FROM: Sharon Nordstrom *SN*
PROJECT: GMC - Fisher Guide
SUBJECT: PCB Data Report

Re: Surface Impoundment Closure Plan
EPA ID NY002239440

This sets forth Fisher Guide's response to the Department's Technical Notice of Incompleteness, which was forwarded under cover of Paul Countermand's letter of July 15, 1988.

FIGURE 3

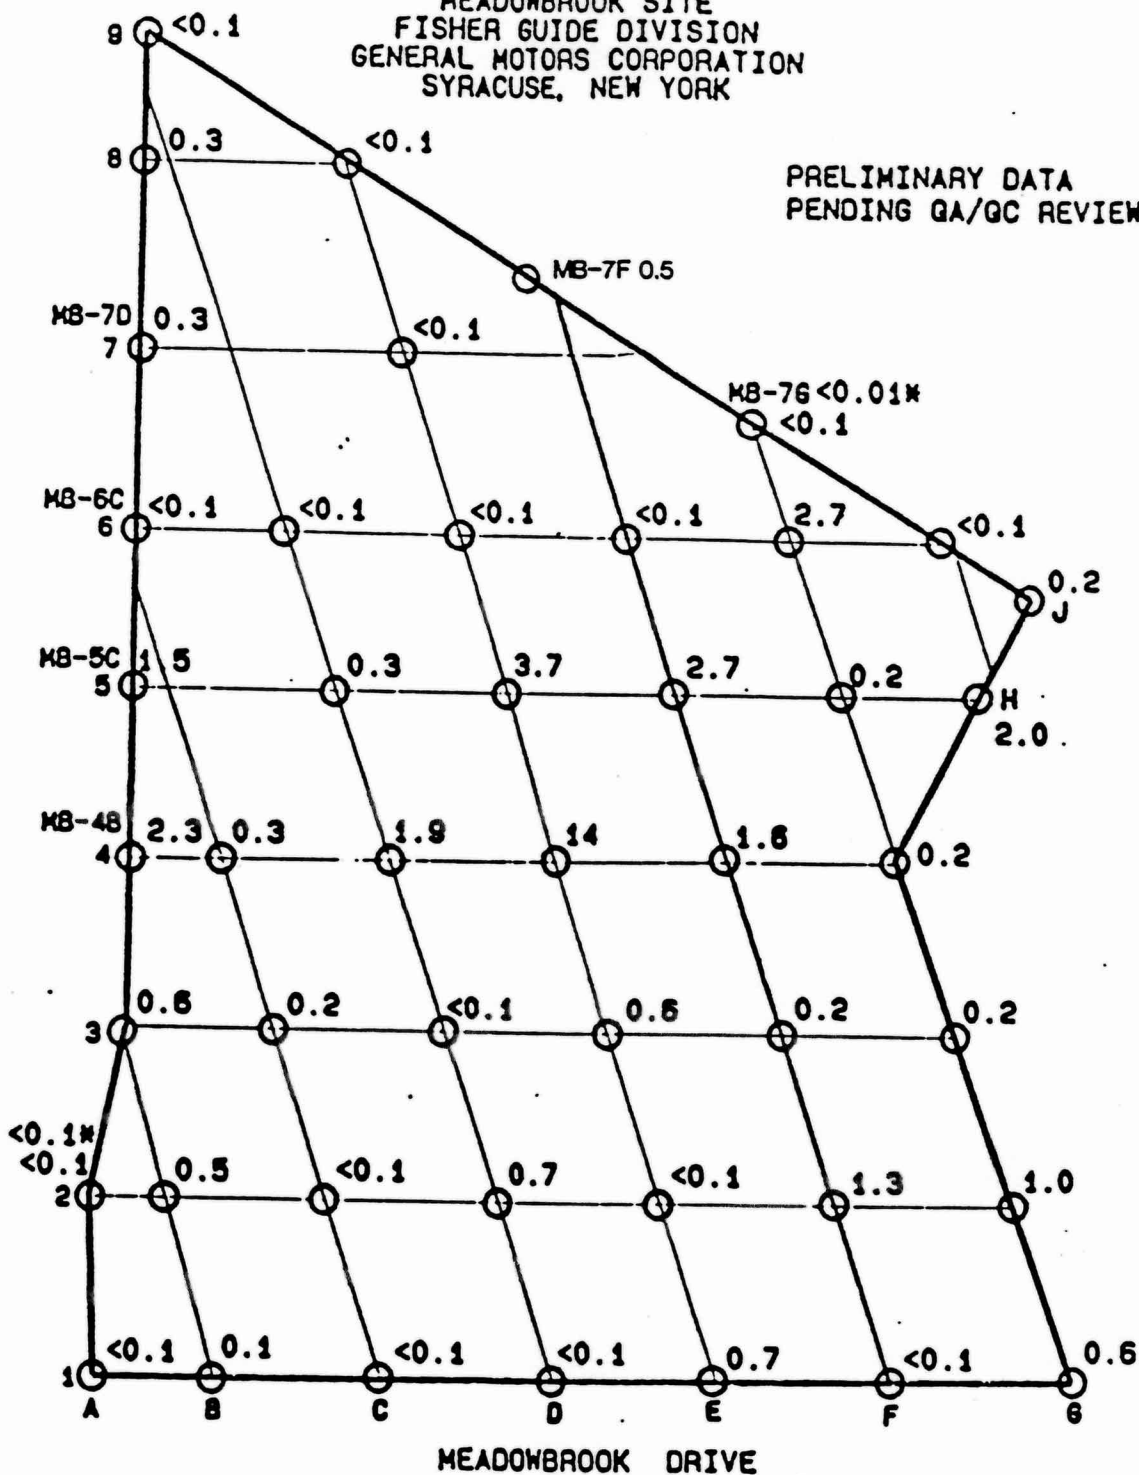
Applicant must not only provide an average for PCB concentrations at Meadowbrook, but also the highest and lowest values.
